May 31, 1983

Subject: Oconee Nuclear Station
Docket Nos. 50-269, -270, -287
NUREG Item II.F.1.4 Containment Pressure Monitor
II.F.1.5 Containment Water Level Monitor
II.F.1.6 Containment Hydrogen Monitor

Response to Request for Additional
Information on NUREG-0737 Items

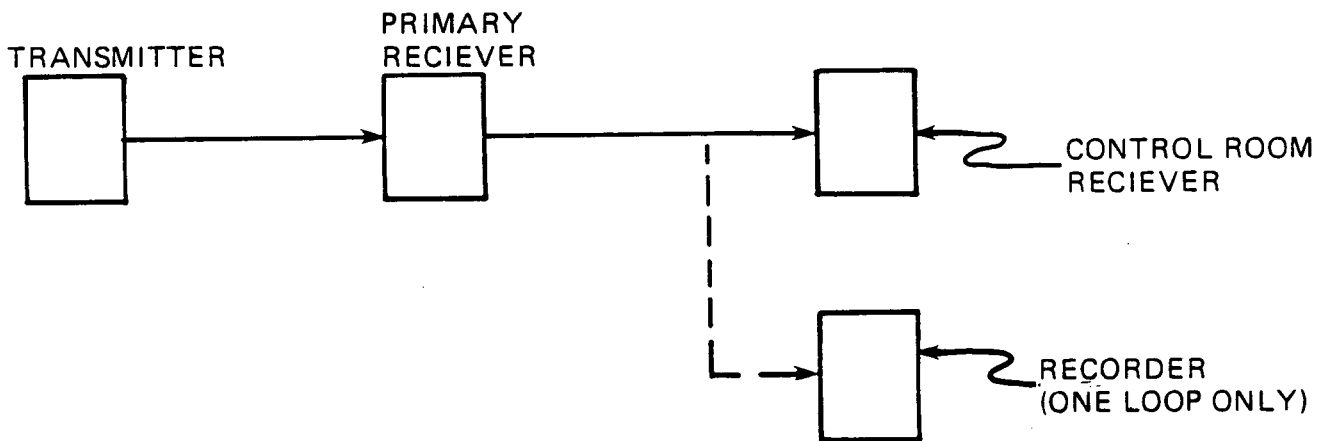
Request: (2a) Provide a block diagram of the configuration of modules that make up your PMS. Provide an explanation of any details in the block diagram that might be necessary for an understanding of your PMS accuracy and time response.

Response:

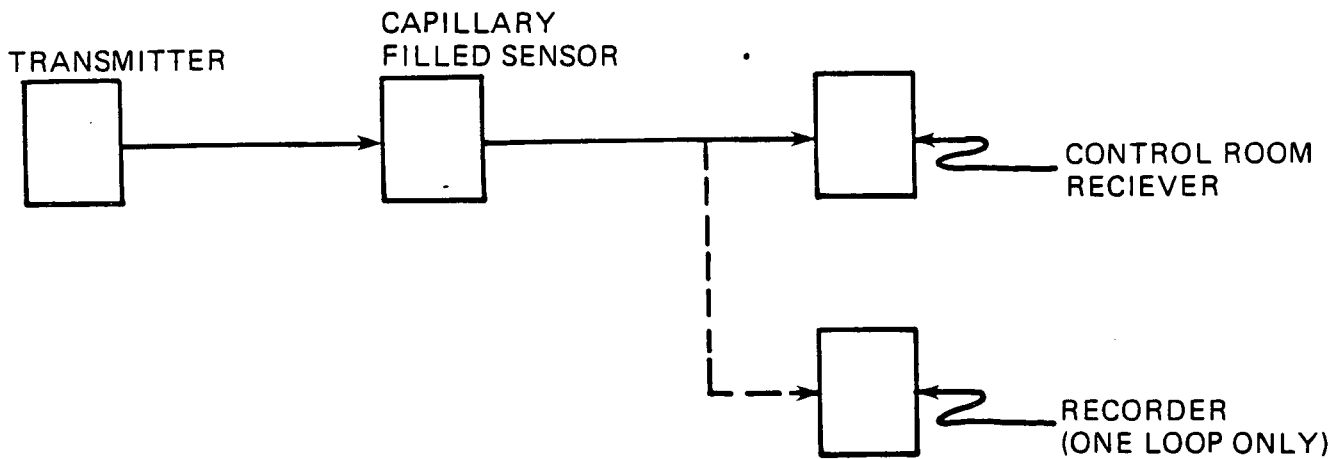
Request: (3a) Provide a block diagram of the configuration of modules that make up your WLMS. Provide an explanation of any details in the block diagram that might be necessary for an understanding of your WLMS accuracy.

Response:

WIDE RANGE SYSTEM

NARROW RANGE SYSTEM

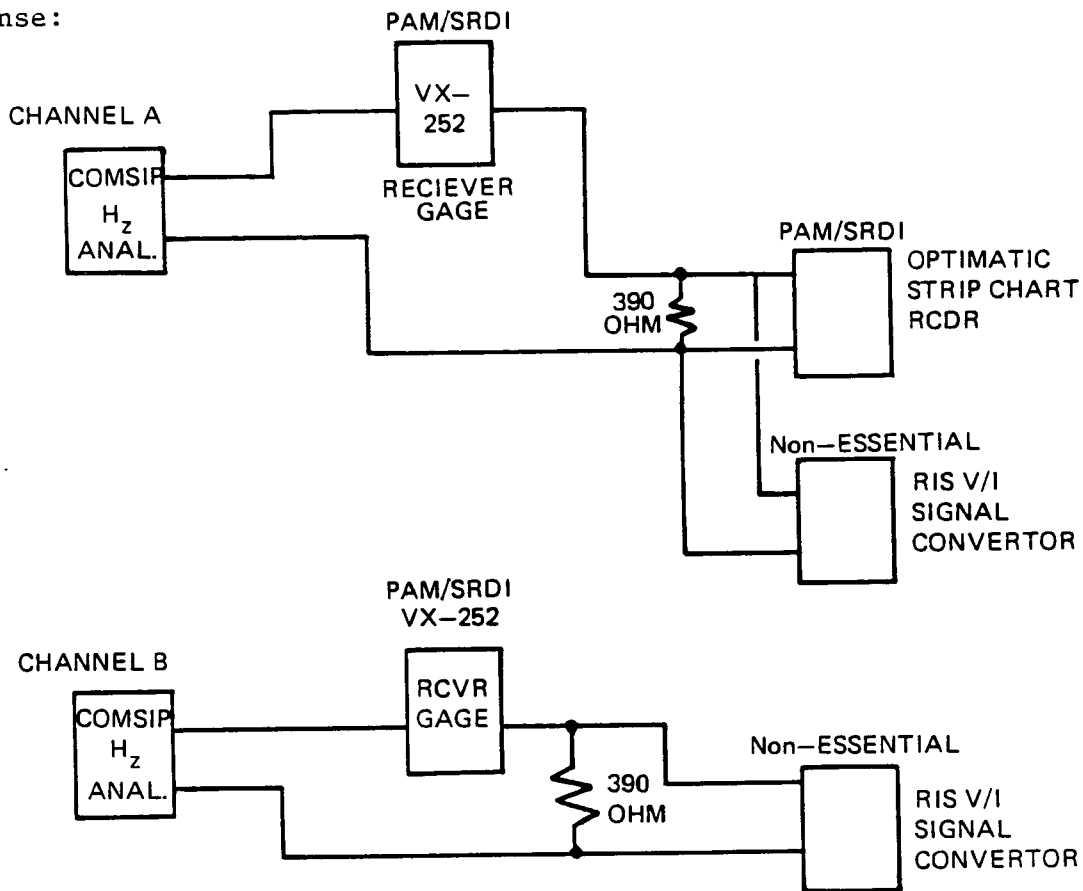
Request: (4a) Provide a block diagram of the configuration of modules that make up your HMS. Provide an explanation of any details in the block diagram that might be necessary for an understanding of your HMS accuracy. If you have different types of HMS give this information for each type.

Response:
